Technical Service BULLETIN

Title: COWL TOP VENTILATOR LOUVER

Models:
'96 & '97 RAV4

BO009-98

Cowl Top Ventilator Louver -

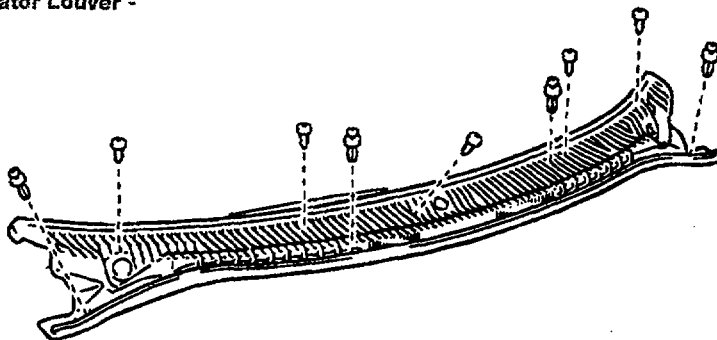
Introduction To prevent snow from entering the cowl vent on 1996 and 1997 RAV4s, stainless steel mesh nets have been added to the cowl top ventilator louver.

PREVIOUS PART NUMBER	CURRENT PART NUMBER	PART NAME
55708-42040	55708-42050	Louver Sub-Assembly, Cowl Top Ventilator

Replace the Cowl Top Ventilator Louver per the Repair Manual procedures.
